**We Advocate Thorough Environmental Review**  
**P.O. Box 873**  
**Mt. Shasta, CA 96067**  
**mountshastawater@gmail.com**

January 8, 2016

We are responding to a request for public comment on the "Proposed Mitigated Negative Declaration and Initial Study: State-Mandated Wastewater Treatment and Outfall Improvement Project, Mt. Shasta CA, November 2015," a 99 page document prepared by ENPLAN, a subcontractor for the City's engineering firm, PACE Engineering (for the remainder of this document, we will refer to the ENPLAN document as MND/IS). The MND/IS refers to a second document entitled, "Draft Preliminary Engineering Report and Feasibility Study for the City of Mt. Shasta State Mandated Wastewater Treatment and Disposal Improvement Project," (referred to here as "PER") prepared by PACE Engineering which we have also referred to in our analysis of the WWTP project.

Figure 5 – Historic Effluent Disposal Volumes

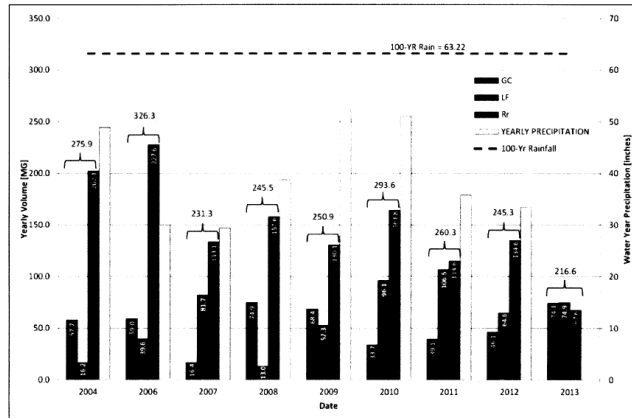
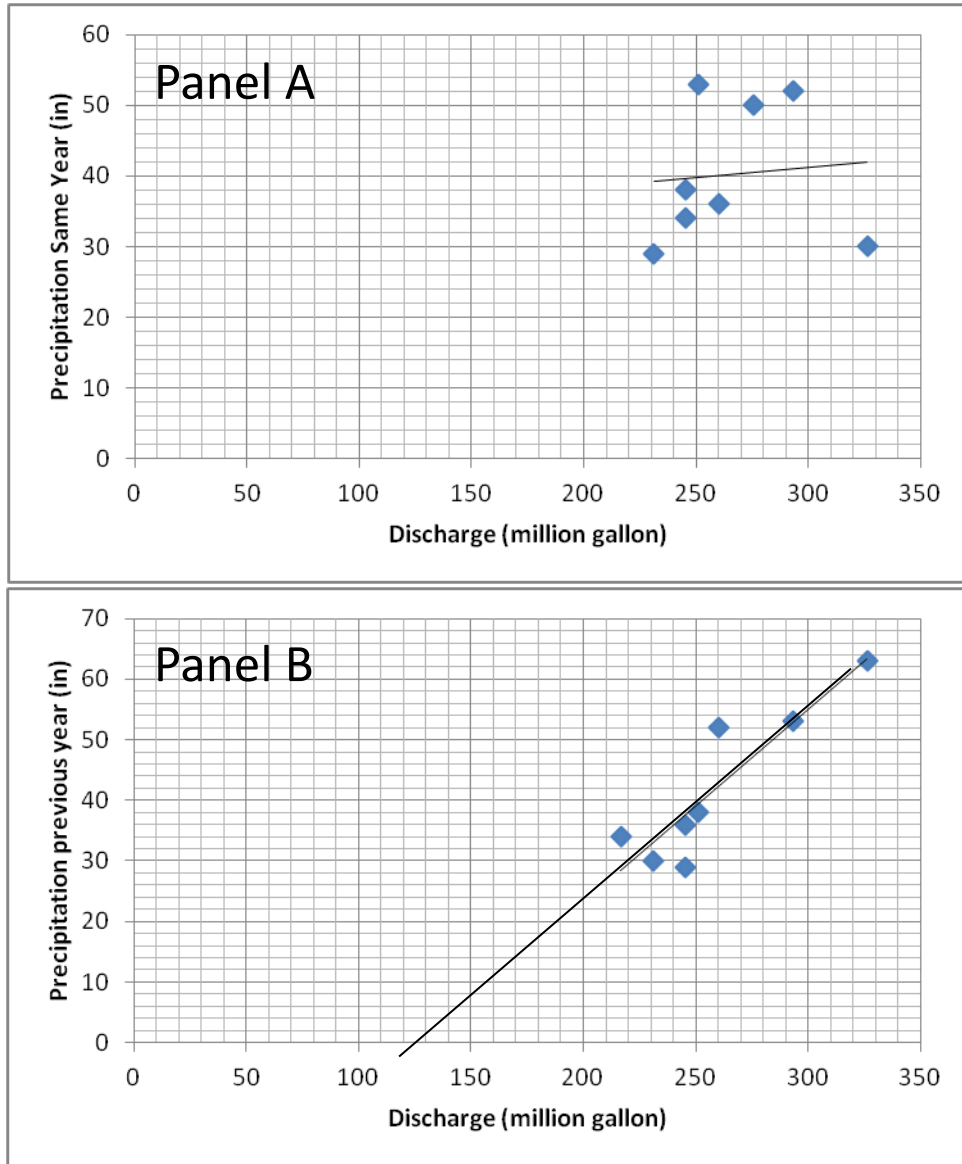
The Document referred to in the MND/IS, "Draft Preliminary Engineering Report and Feasibility Study For City Of Mt. Shasta State Mandated Wastewater Treatment And Disposal Improvement Project" contains data of the annual total WWTP discharge and precipitation (figure 5, page 28)

This data can be plotted as a line graph of precipitation vs discharge as seen below: Panel A is with discharge and precipitation for the same year. Panel B shows the discharge data plotted with precipitation from the previous year.

Panel A shows no apparent relationship between WWTP discharge and current year precipitation. In contrast, Panel B shows a strong linear relationship between WWTP discharge and precipitation from the PREVIOUS year. There are two significant implications from this data:

- 1). When the line of the best linear fit to the data is extended it intercepts the x-axis at about 125 million gallons, implying that if there were no precipitation, the WWTP would only need to process approximately 125,000,000 gallons per year, 1/2 to 1/3 of the historical need over the past 10 years.
- 2). The fact that there is a strong relationship between annual discharge and precipitation from the PREVIOUS year, and no relationship between discharge and precipitation from the same year, suggests that the contribution of precipitation to the discharge volume is not due to immediate run-off, but rather water that is in the ground. Although we acknowledge that correlation does not mean causation, this analysis points again to the likelihood that problems

with the collection system are significant and have implications for the accurate analysis of needed WWTP capacity, and more research needs to be undertaken to fully and accurately understand the capacity needs of the WWTP.

Figure 2 – Effluent Copper & Zinc Comparison

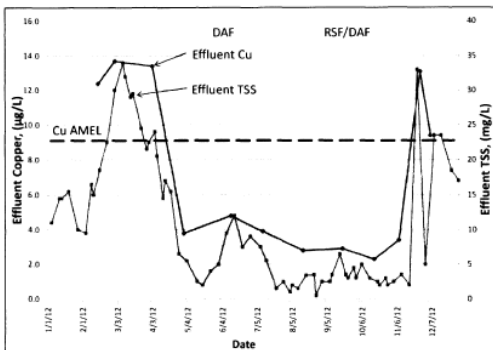
The Document referred to in the MND/IS, "Draft Preliminary Engineering Report and Feasibility Study for City of Mt. Shasta State Mandated Wastewater Treatment and Disposal Improvement Project" contains data for copper, zinc, and total suspended solids (TSS) (figure 2 and 3, page 20) for 2012 (note figure 2 is mislabeled).

In this document we are told there is "a strong correlation between TSS and copper and zinc, suggesting removal of TSS through efficient biological treatment and effluent filtration will be required in order to comply with [copper and zinc requirements of] the new permit." This statement does not logically follow from the data presented nor is it substantiated by the data. Yes, there is an apparent correlation between TSS and copper and TSS and zinc in the data that is given, but correlation does NOT mean causation. The data in figures 2 and 3 are incomplete. We have been told that TSS increases in the winter because the filtering system cannot operate in

the winter months, yet the TSS data in figures 2 and 3 show peaks in TSS in November and March, but a substantial valley in December through February when the filters are not functioning. Also of importance is that there are no data for copper and zinc from mid-December through mid-February when the TSS is relatively low. Why not? Surely that data must have been collected. And certainly there must be data sets for additional years. Why not include them? We request more thorough and definitive chemical analyses be done of the effluents that contain high levels of copper and zinc to determine if the copper and zinc are indeed bound up in the TSS and will indeed be removed by the filtration system.
